**Valley Shop Renovation
Contract No. BE18-241**

ADDENDUM NO.: TWO

June 21, 2018

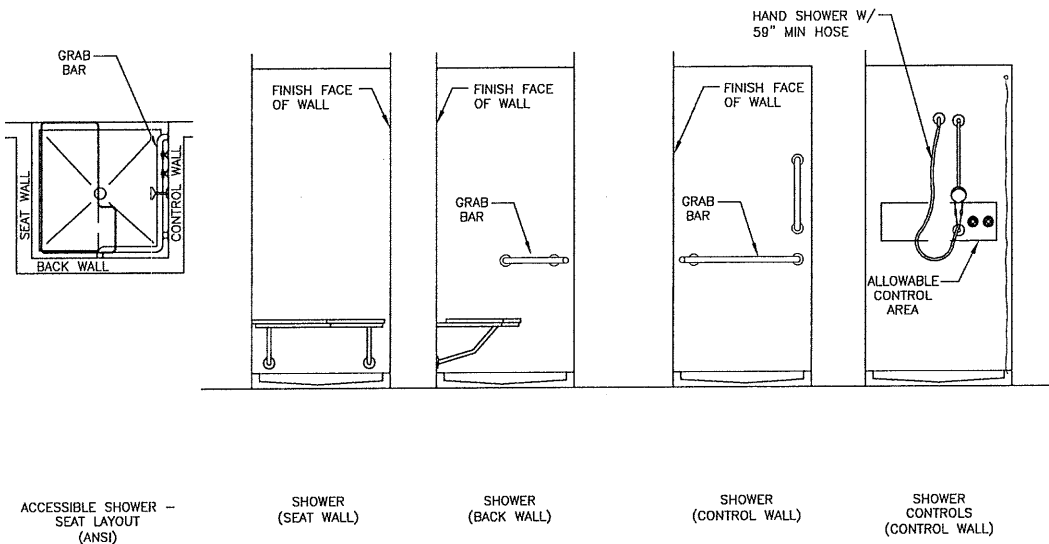
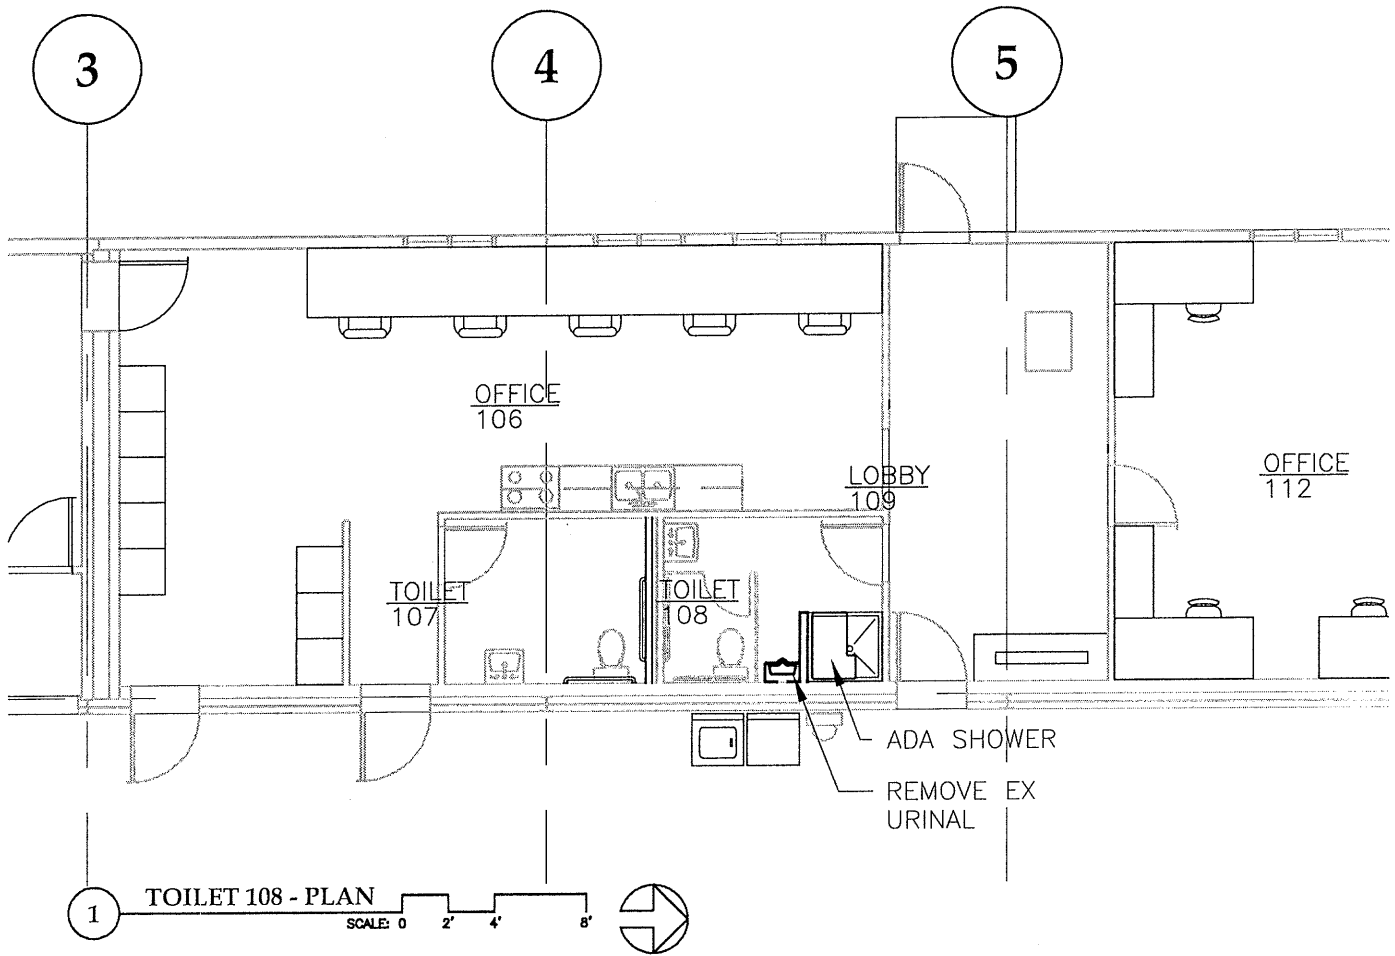
- Item No. 1 Sheet A201 FLOOR PLAN, at toilet 108; **Delete** floor at gridline G4.5 "EXTENTS OF SV." - **Add:** "EXTENTS OF CONC SLAB AND SV"
- Item No. 2 Sheet A201 FLOOR PLAN, at Toilet 108; **Delete** shower at gridline G4.5
- Item No. 2 **Add** Sheet SK2 Shower Details/Elevations after Sheet A901 INTERIOR DETAILS
- Item No. 3 Sheet M301 SPECIFICATIONS, **Add** ADA Shower - basis of design - Freedom ADA Transfer Shower 39" x 38", **Model** APFQ3682BF625 to SECTION 15450 - PLUMBING FIXTURES AND TRIM

Detail Of Threshold

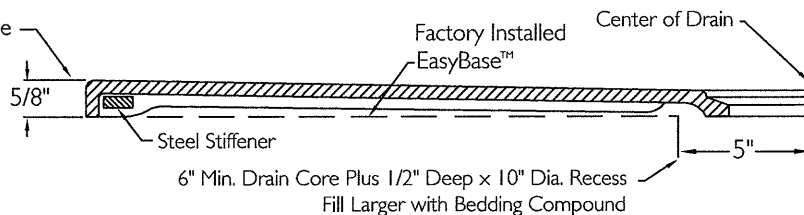
Coordinate Finished Floor Height For Code.
Finished Floor May Be No More Than 1/4\" Below The Top Of Compartment Threshold.
